SUBJECT: MEETING NOTIFICATION AND TRANSMITTAL OF TENTATIVE AGENDA

Wednesday, September 5, 2012 at 1:30 p.m.
MAG Office, Suite 200 (Second Floor), Ironwood Room
302 North 1st Avenue, Phoenix

MAG Standard Specifications and Details Committee
TENTATIVE AGENDA
September 5, 2012

DETAIL NO.
201

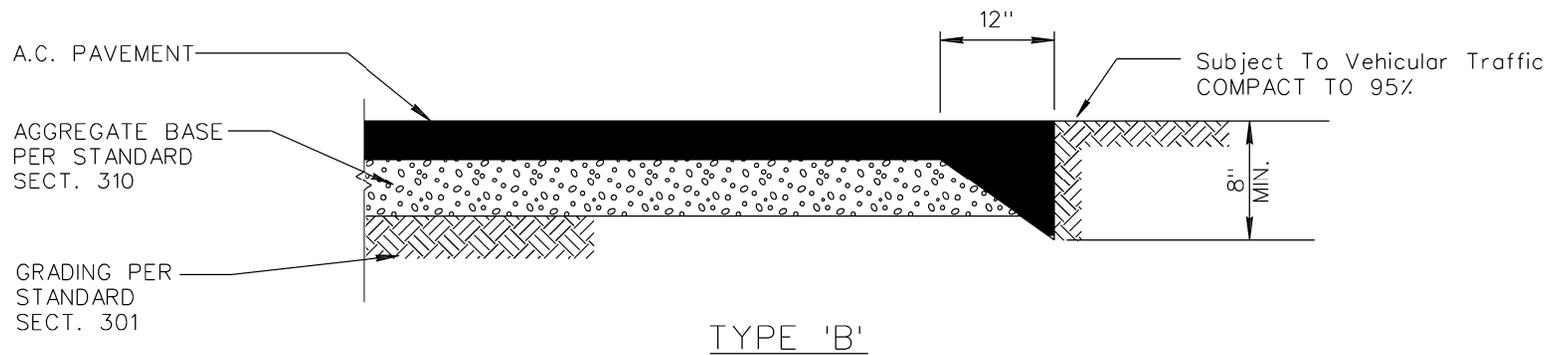
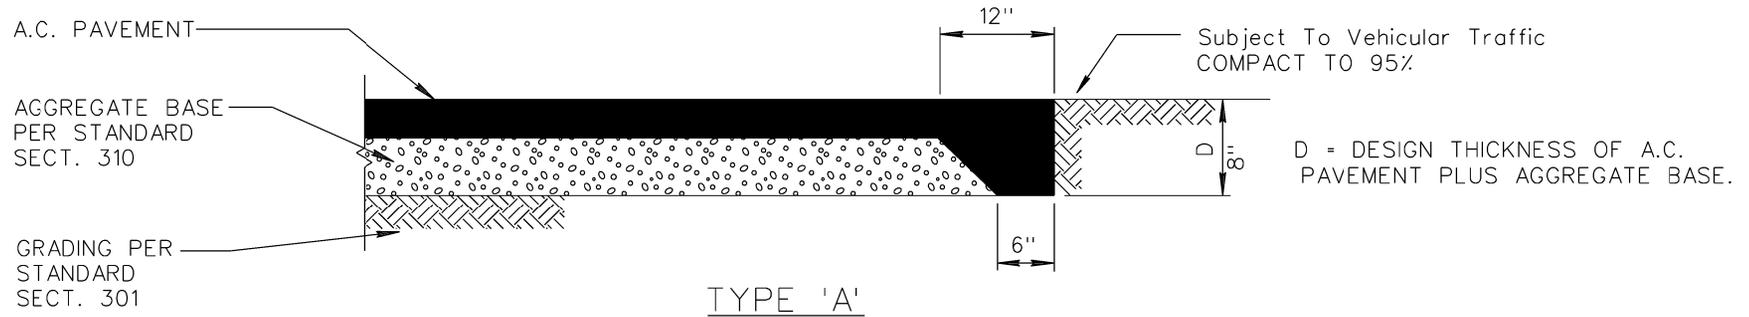
Add an Asphalt Pavement Safety Edge option to Detail 201, update Section 321.8. Bob Herz handed out a revised version of the written specifications (Section 321.8.8 and Section 321.8.9) to go along with the updated detail drawing that was provided in the packet. He said he modified Section 321.8.9 to form the angle with respect to the adjacent roadway surface rather than the horizontal plane. Brian Gallimore asked how the roadway was to be fixed if the safety edge shape is not fully formed. Members suggested several methods of repair, depending on what and how much had to be fixed. Mr. Herz said he felt it should be left open to allow the contractor to fix it in the way deemed most appropriate for the situation. Mr. Gallimore said he also could get more specific language to replace the term “special device” based on actual devices approved by FHWA. Mr. Herz then asked for comments on Detail 201. Tom Wilhite suggested adding the note, “unpaved shoulder recompacted to 95%” on sections ‘A’ and ‘B’ as well. Brian Gallimore agreed and Bob Herz was okay with the change, although he thought it was covered in the written specifications. Mr. Herz agreed to make the final revisions and called for a vote at the next meeting.

321.8.9 Safety Edge: The finished safety edge slope shall be planar forming a $30^{\circ} \pm 5^{\circ}$ angle with the adjacent roadway surface and extend a minimum of five inches (5") below the roadway pavement's finished surface.

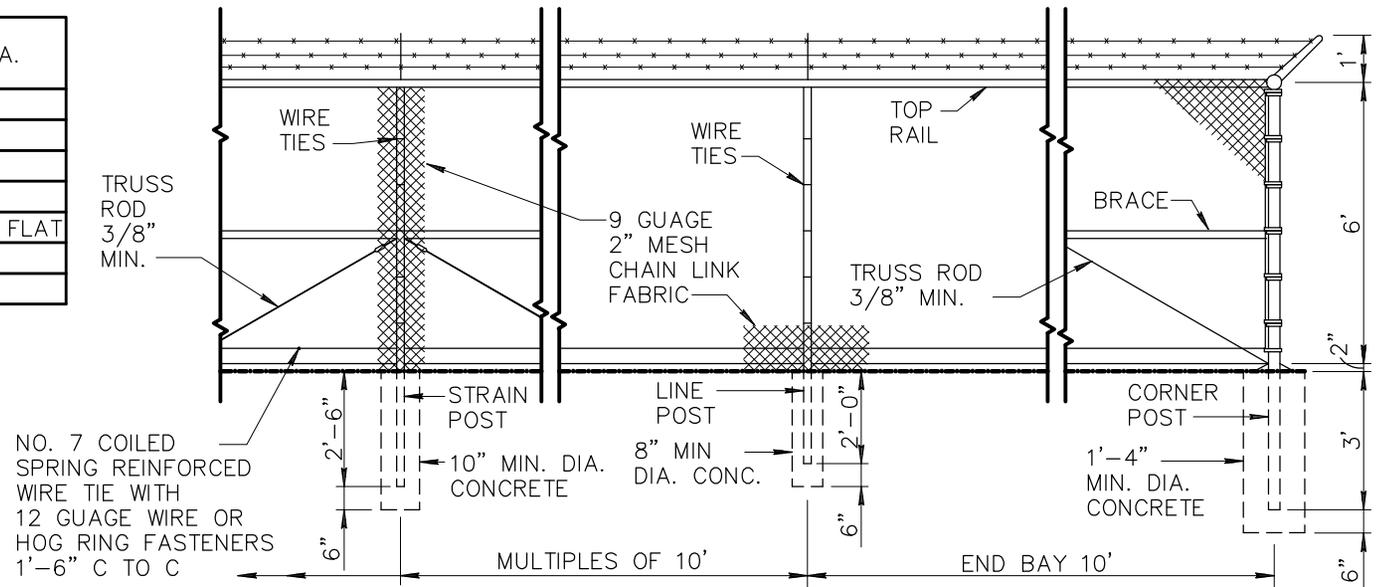
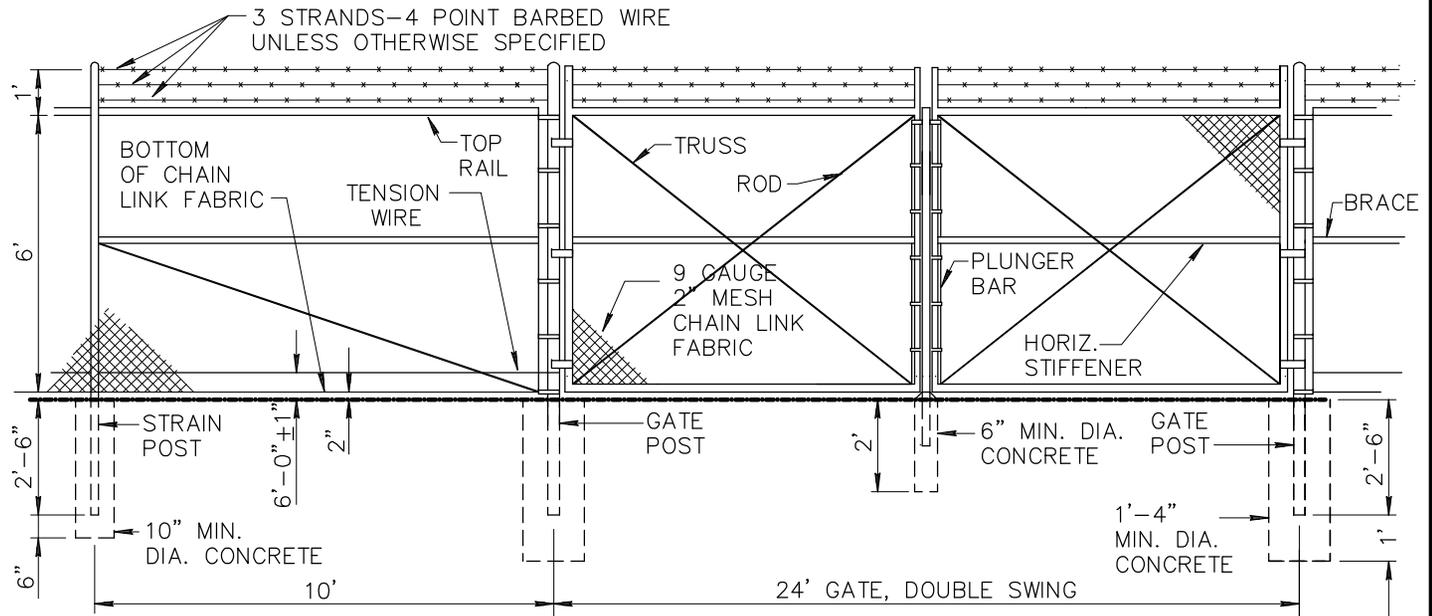
Should refer to Section 772 and Table 772-1.

DETAIL NO.
250-2

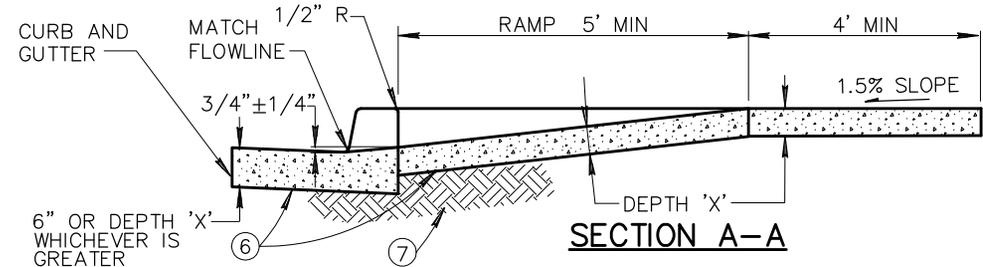
Update Sidewalk Widths to 4' in Detail 250-2 Driveway Entrances. Bob Herz provided an updated detail drawing at the meeting that adjusted note #2 to match Tempe's detail. It also adjusted the driveway entrance width to accommodate widening, and fixed the dimensions. Bob Draper asked why there was a 1' dimension from the beginning of the warp to the expansion joint. Mr. Herz explained that the expansion joint had to be moved a foot to keep the joint perpendicular to the sidewalk, and still keep a minimum 4' width for the entire path. (He noted that the 4' width is the minimum allowed under the proposed ADA standards.) With no further comments, Mr. Herz proposed to vote on the case during the next meeting.

TYPE A - WITHOUT RETAINING CURB

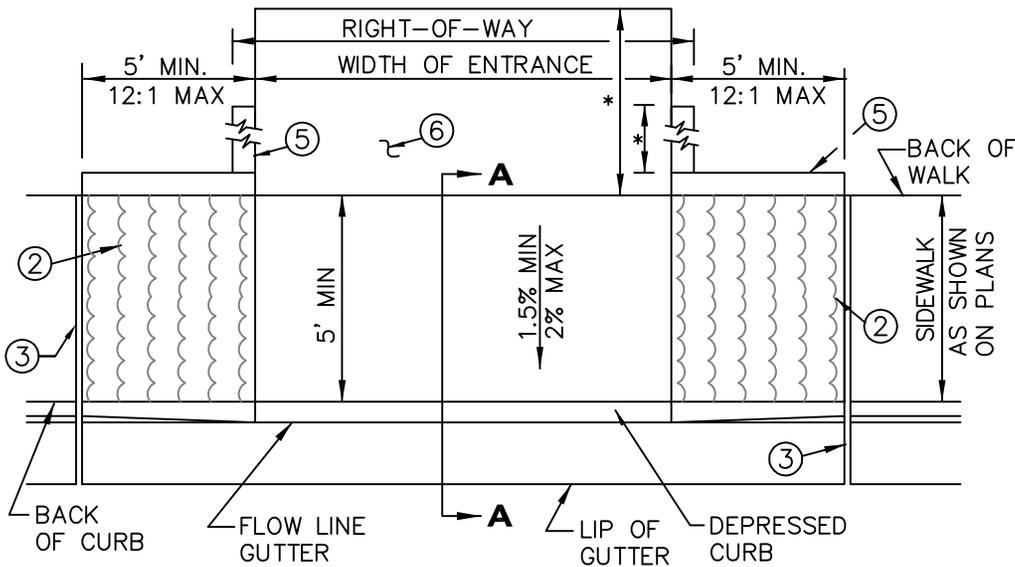
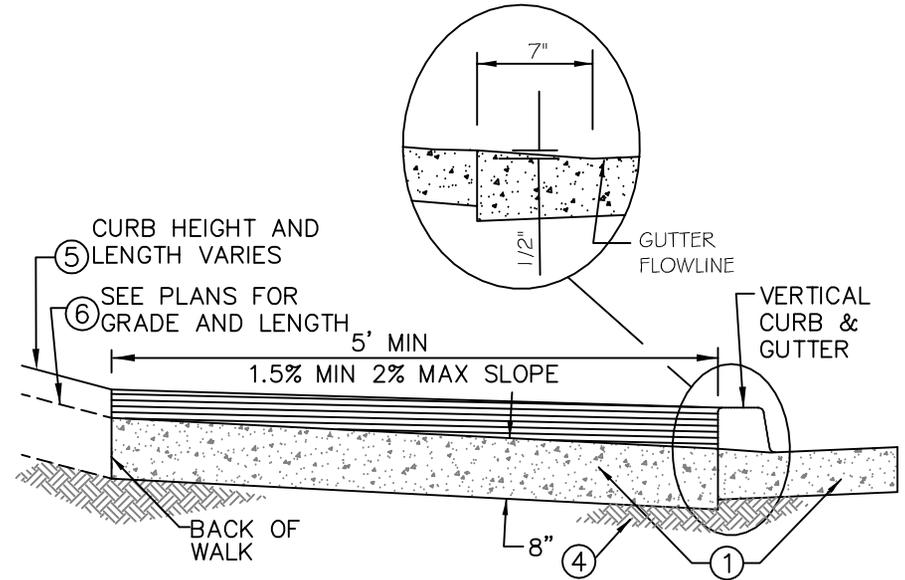
Create a new entrance detail meeting ADA requirements for straight sidewalks. Warren White provided an updated Alley Entrance Detail 260 during the meeting and also noted photos showing an installation were provided in the packet. The new Detail 260 showed two types, A-without curb, and B-with curb. Other revisions were made based on comments from the previous meeting. Bob Herz said he believed Note 3 should be referencing Section 340 instead of 390. Mr. White clarified that Note 5 is referring to the optional curb on the left side of the Type B view. Jason Mahkovtz and Greg Crossman suggested showing the concrete pad at the top of the driveway entrance. Members discussed the length of the curb and pad, and decided that it should be shown on the plans since it would depend on the site. It was also determined that the pad was to be Type A concrete as, but that the slope did not need to be specified since it was not part of the pedestrian walkway. Bob Draper noted that this detail could be used for other entrances besides alleyways. It was suggested to show the track-out pad in Section A-A view as well. Finally, there was discussion about transitioning from existing sidewalks, including those larger and smaller. For smaller sidewalks such as those 4’ wide, members suggested adding the transition to one the side of the detail, like what was done in a previous curb ramp details. Mr. White said he would incorporate the improvements and have a final detail prepared for a vote at the next meeting.

360-1

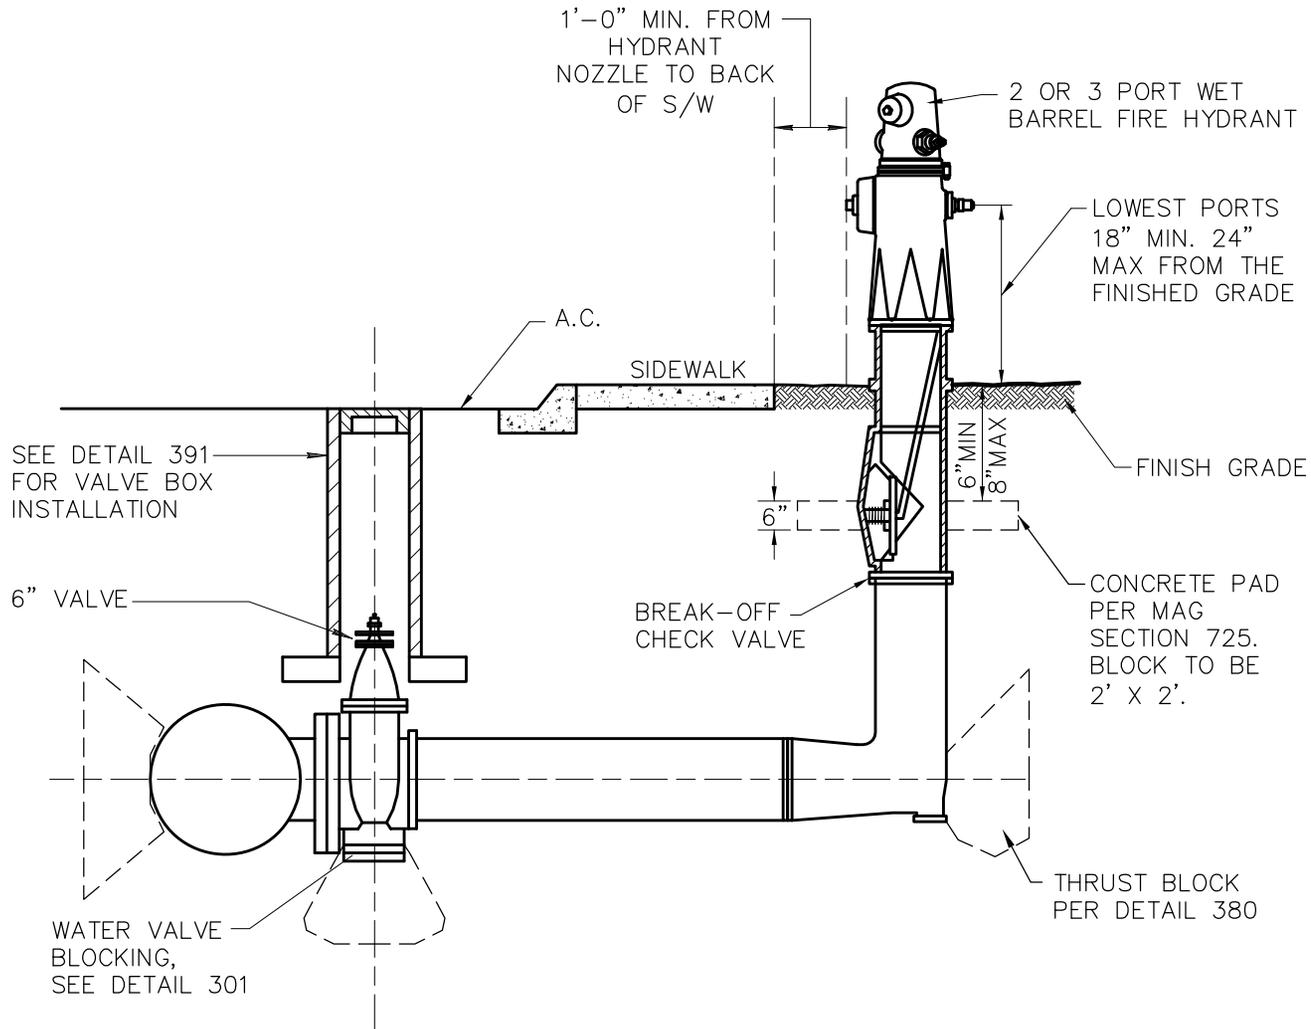
Update Detail 360-1, and add Wet Barrel Option (360-2) and Details (360-3). Craig Sharp said the revised details in the packet included the minor corrections noted at the last committee meeting. It was also reviewed during the July water/sewer meeting. Bob Herz suggested a few minor corrections including changing note 7 to read “No valves are to be **located** in curb.” Discussion about situations when valves do end up in the curb or gutter followed; however, members thought as a default for new construction, note 7 should be included. Mr. Herz also suggested removing references to MAG since all references by default are to the MAG specifications, and to add the word “acceptance” to the end of Note 10. Finally, he said the note for the second concrete pad should say “alternate location for concrete pad...” No changes were proposed for detail 360-3. Jami Erickson moved to accept Case 11-14 with the changes as discussed. Jim Badowich seconded the motion. A roll call vote was taken. The motion passed. 11 yes, 0 no, 0 abstain, 3 not present.
